CHAPTER 5

Responses to Individual Comments

Subject: SCH #2018112070 – Oakland Waterfront Ballpark District

Figure 5.1-1: Google Earth 3-dimensional building image of Schnitzer P-14 (back) and P-15 (front) stacks as viewed from the south.

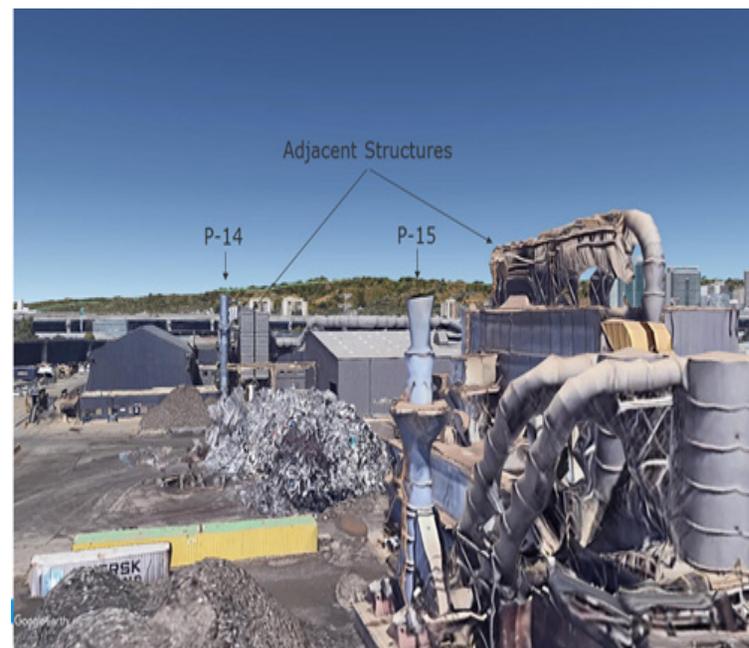
where H is the height of a nearby structure and L is the lesser of the height or projected width of a nearby structure.⁴⁹ In order to be above the downwashed flow, the stack heights would need to be raised to the value of H_g. As seen in the Figure 5.1-1 below, the stack heights are approximately only the height of the nearby structures (H), thus will do not meet the definition of GEP.

During Full Buildout, tall Project buildings will be adjacent (to the east) to the Schnitzer property. Review of the climatological wind direction in the area demonstrates a predominant wind flow from the west to the east (see Figure 5.1-2). Based on this climatology, the Schnitzer property is predominately upwind of the Project site and the effect of downwash from the Project buildings on the Schnitzer property is expected to be infrequent as explained below. The EPA guidance on downwash, and its implementation through the Building Profile and Input Program (BPIP), limits the influence of buildings to $2L$ in the upwind direction, where L is the lesser of the height or projected width of a nearby structure.⁵⁰ Therefore, downwash effects due to the Project buildings are expected to be limited to eastern portion of the Schnitzer property during the predominant wind flows as shown in Figure 5.1-2.
